CENPD-283-NP-RAI
(NRC TAC No. M86126)

**BWR ECCS Evaluation
Model: Boiling Water
Reactor ECCS
Evaluation Model:
Response to Request for
Additional Information
on Code Sensitivity for
SVEA-96 Fuel**

June 1995

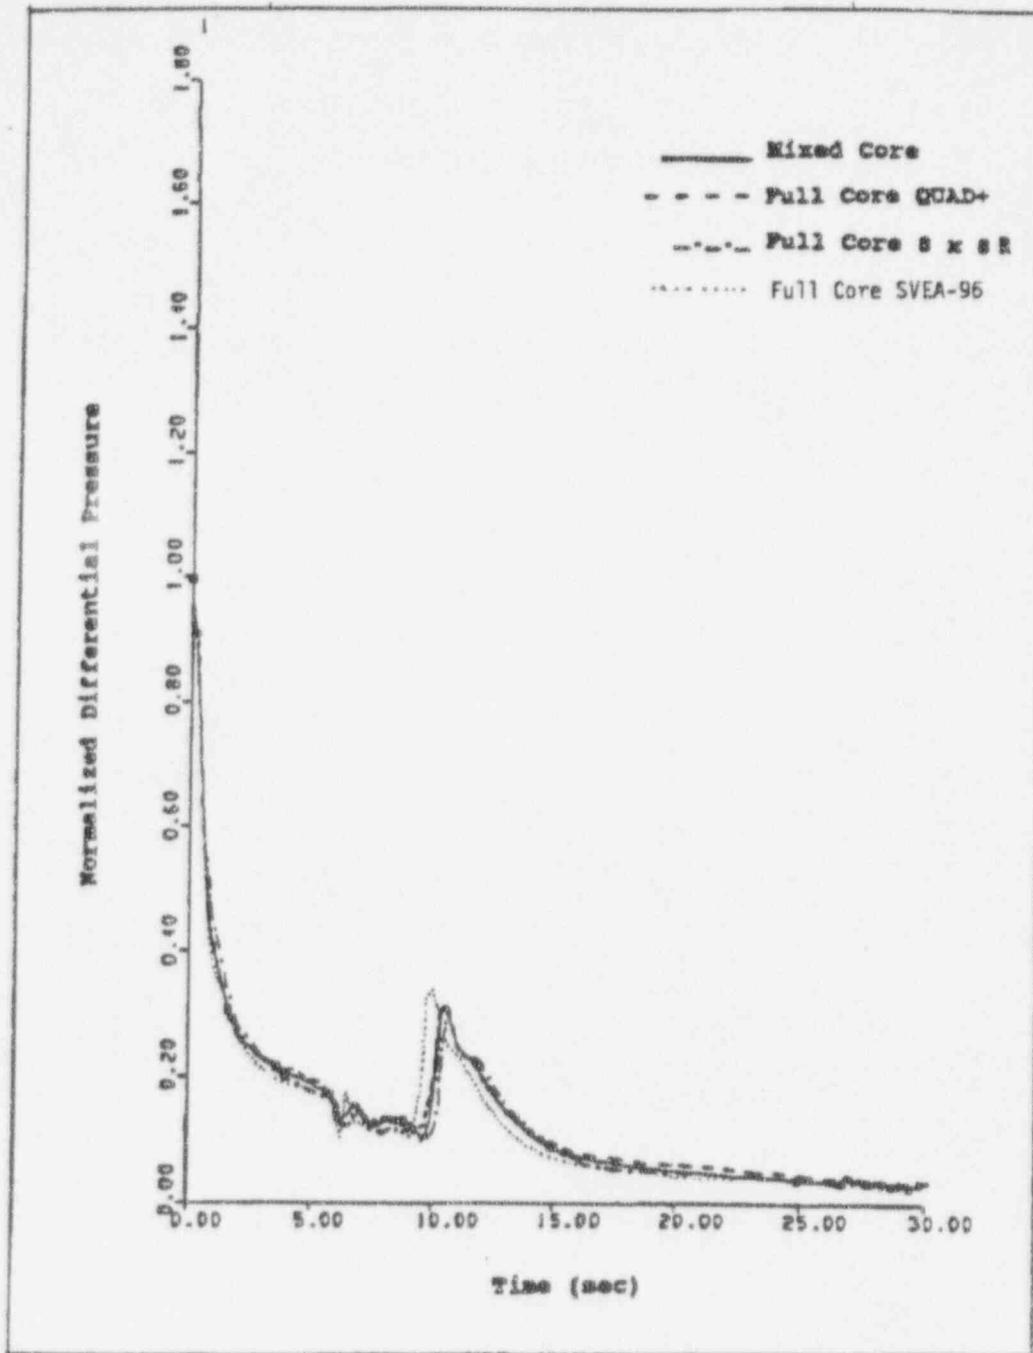
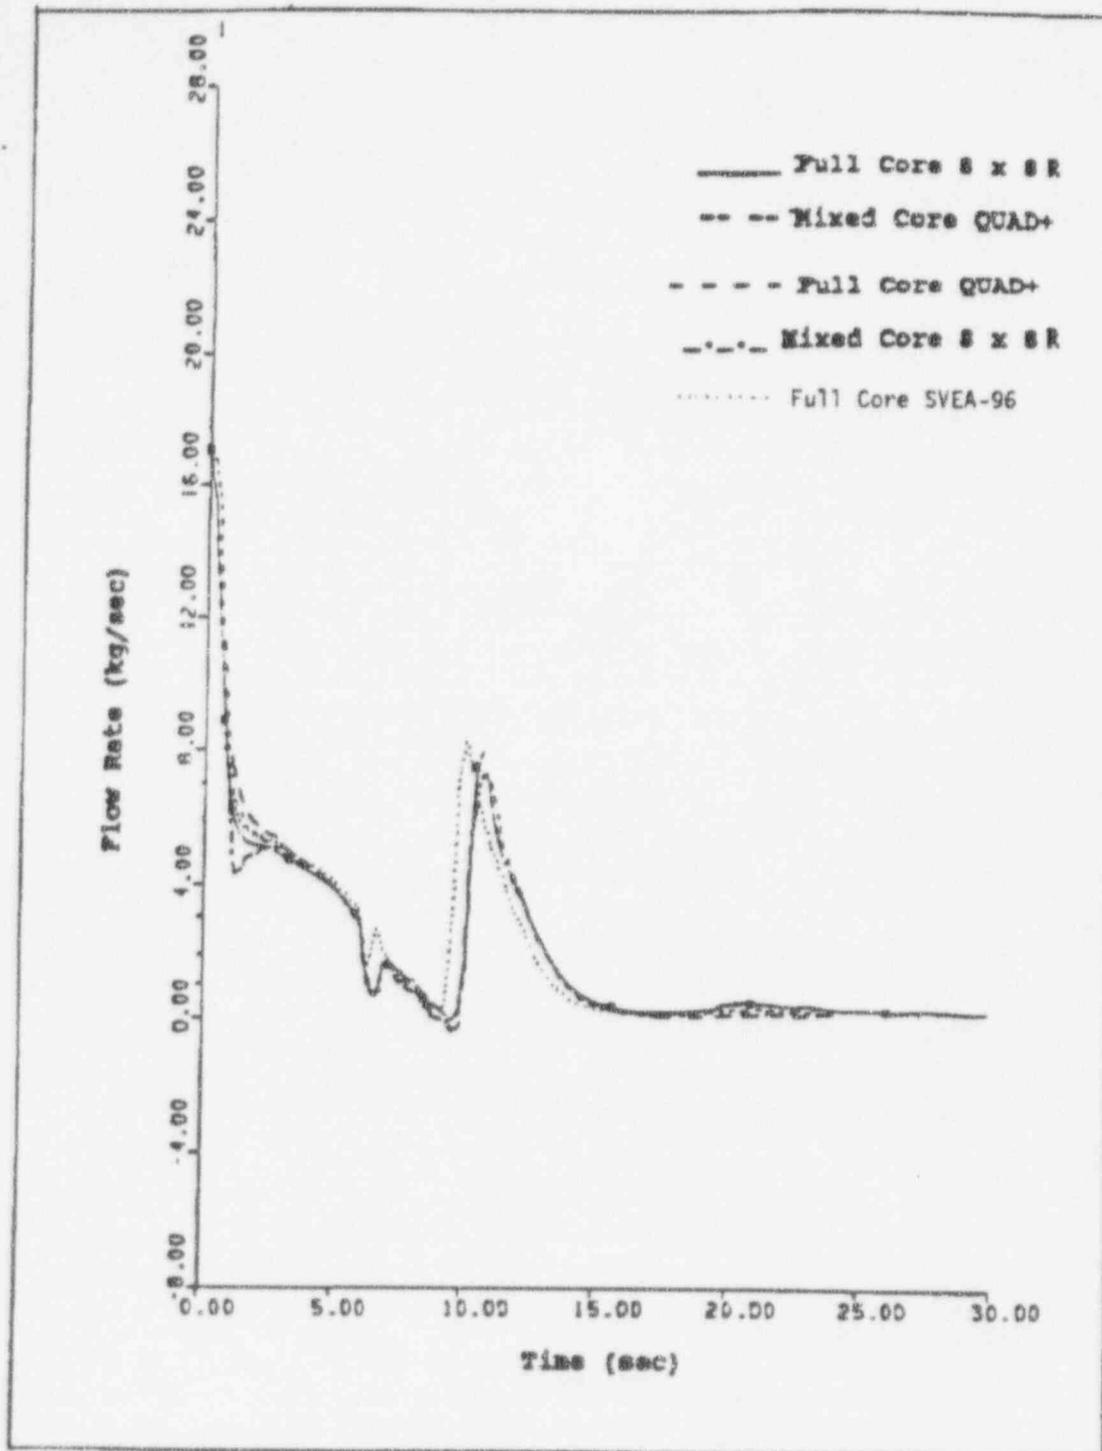
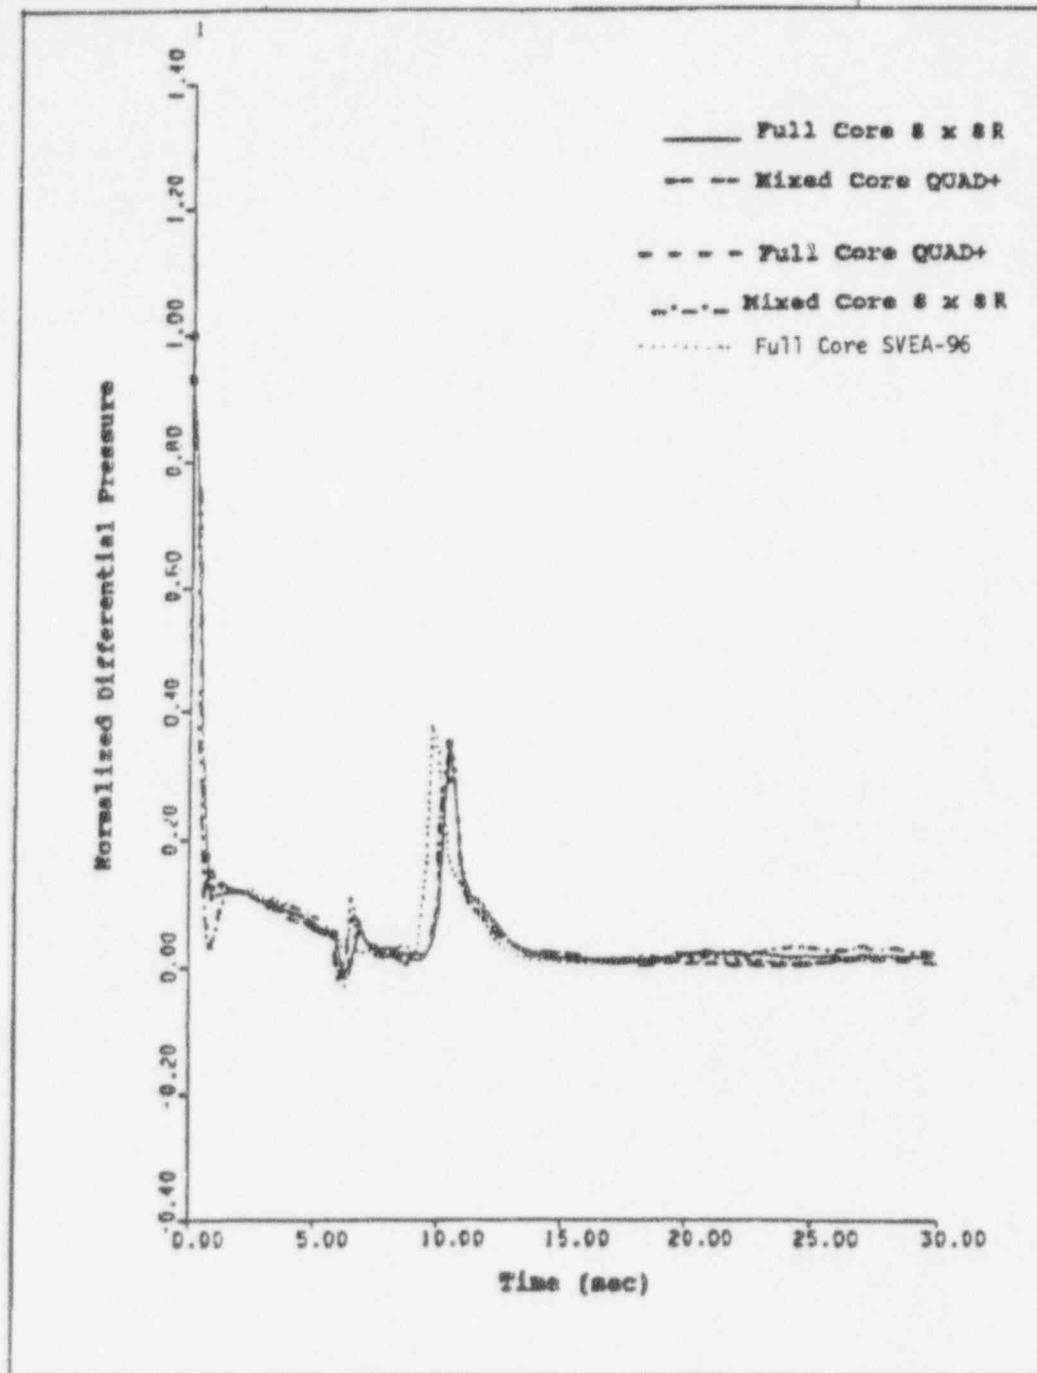
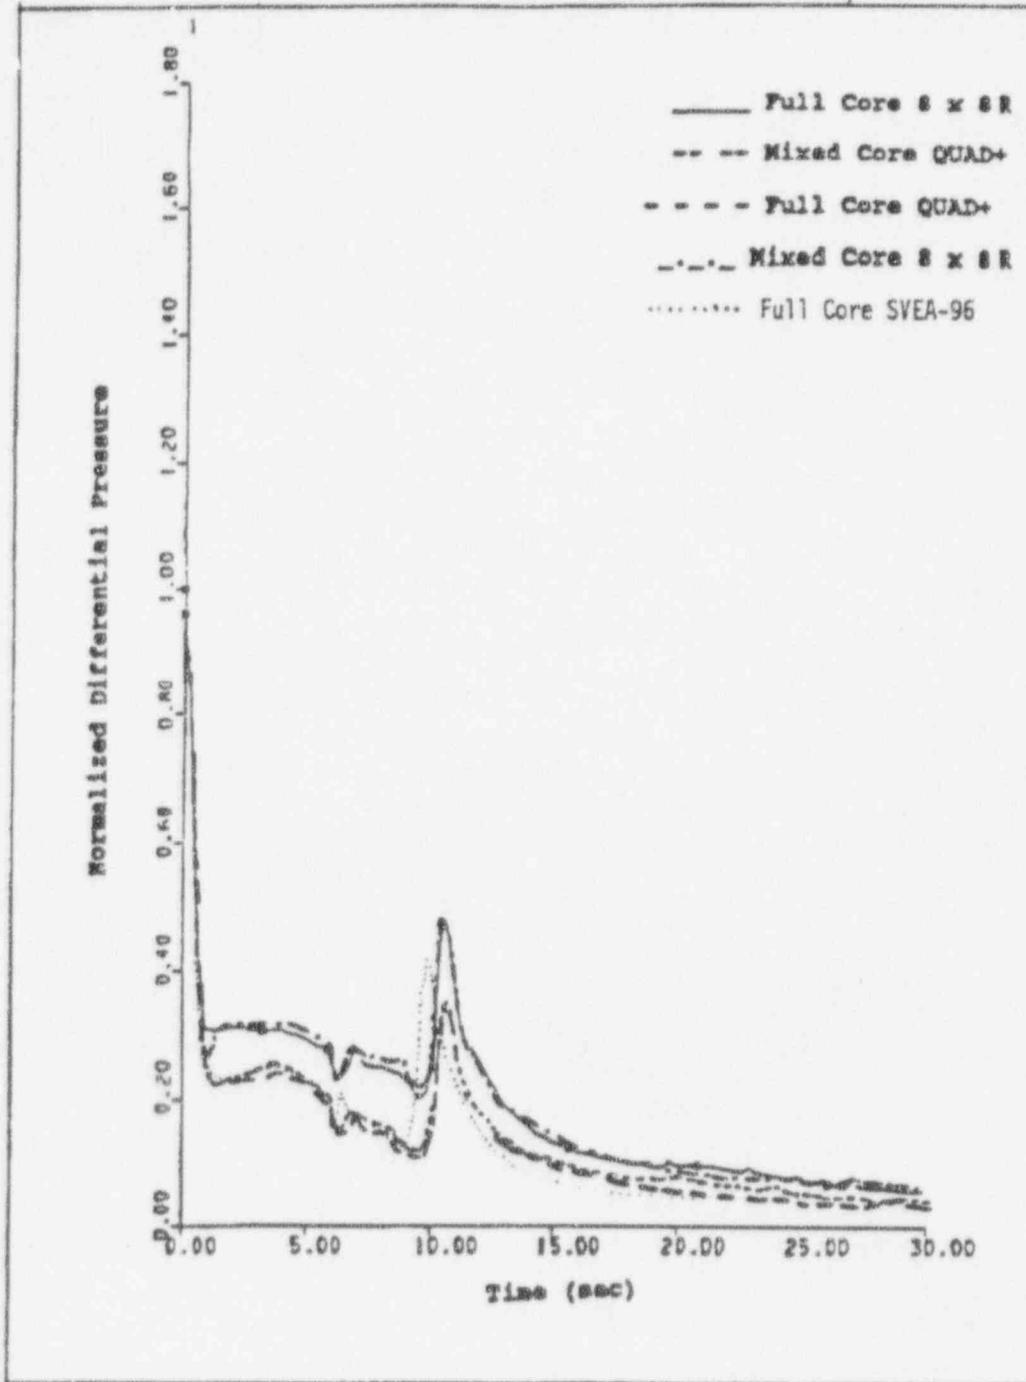
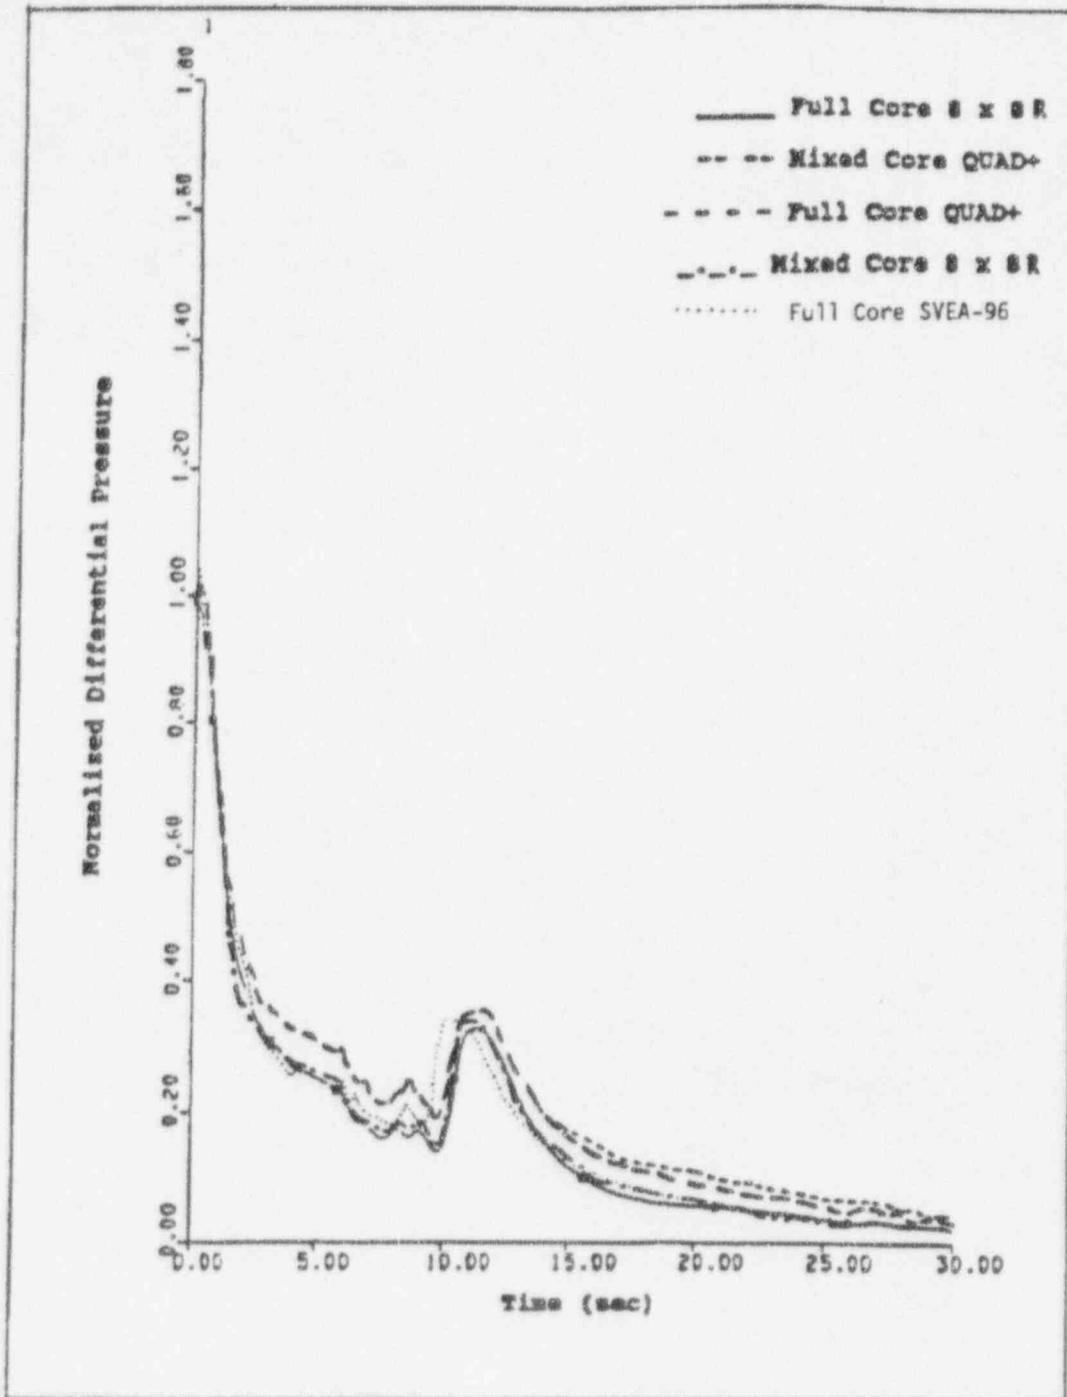
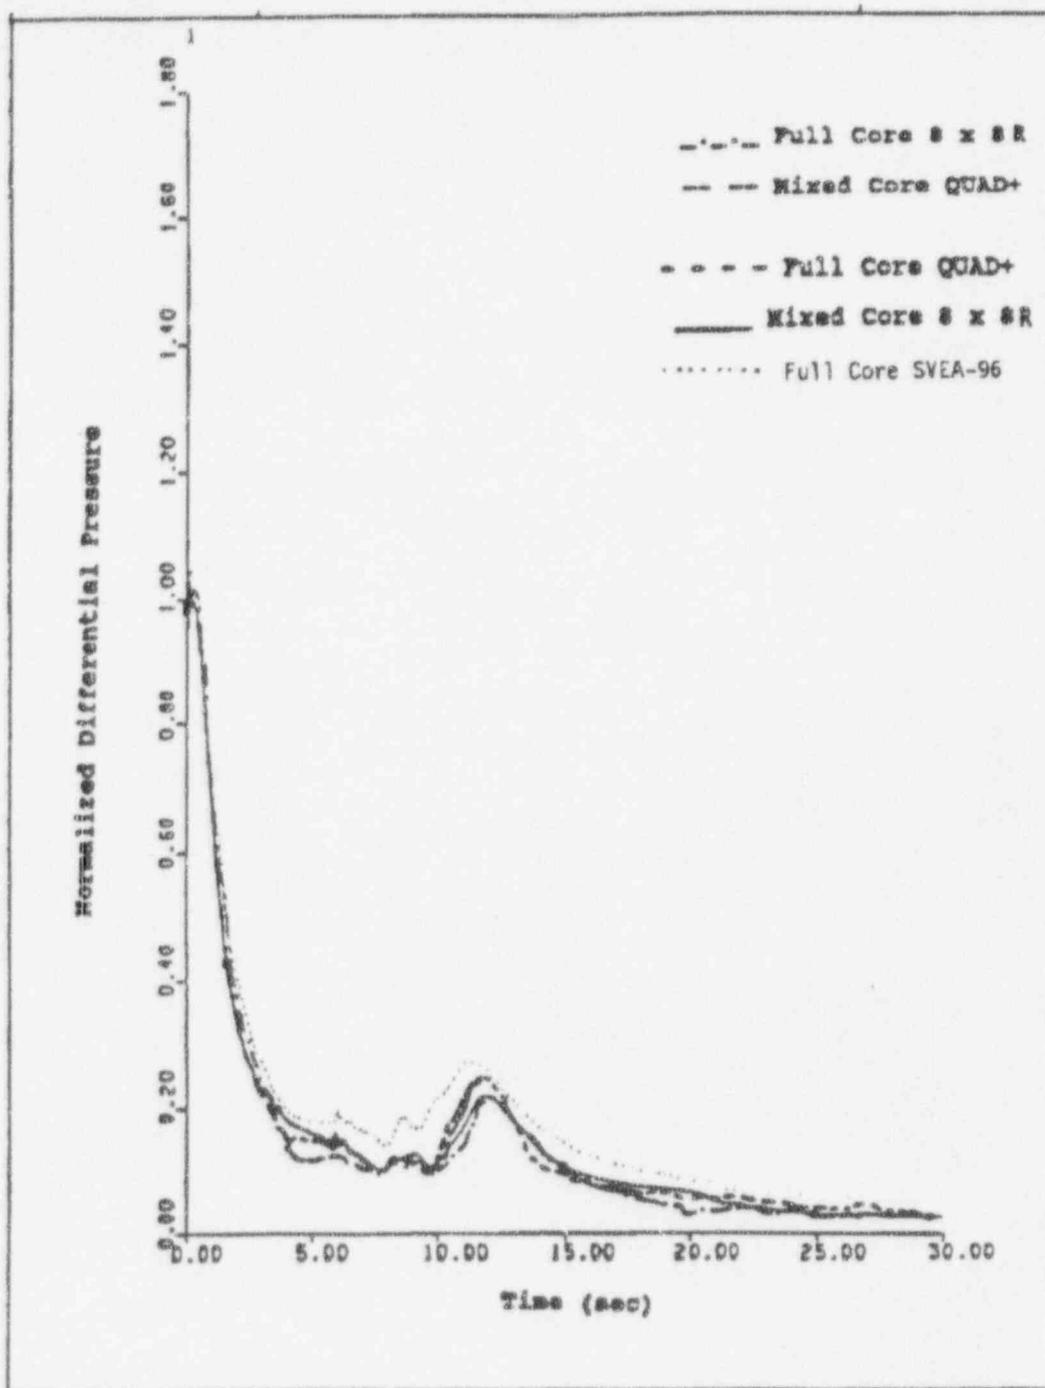
Mixed core effects should be investigated further to support ABB/CE's position regarding the transition cores by presenting mixed core analysis results with transition from QUAD+/SVEA64 fuel to SVEA-96 fuel. The watercross for each fuel design should be explicitly modeled in the nodalization. Provide plots from core void fraction, pressure, flow, and flow velocities.

A sensitivity study for transition cores was reported in response to Question 5 of RPB-90-94-P-A (Reference A5). To further demonstrate the discussion presented and conclusions drawn in the response to Question 5 of RPB-90-94-P-A are valid in general, the results for a full core of SVEA-96 were compared to the previous system responses in Section 8 of Reference A1. Additional comparative results are shown in Figures A9-1 through A9-8 which correspond to Figures 5-1 through 5-8 on pages 18 through 25 of the Addendum to RPB 90-94-P-A. There are insignificant differences between the system responses of the four cores presented.

As discussed in Response 5 of RPB-90-94-P-A small differences in the responses are attributed to differences in fuel component designs. As noted in Response A1 of this document, the SVEA-96 core used as an example was not specifically design to be hydraulically comparable with the previous example cores (i.e., QUAD+ and 8x8). Hence, in some instances in Figures A9-1 through A9-8, the SVEA-96 results deviated slightly more than those observed for the other cores configurations. However, the overall system responses are very similar.

The results presented here further substantiate the general conclusion that the core average system response is relatively independent of local differences in fuel assembly design.
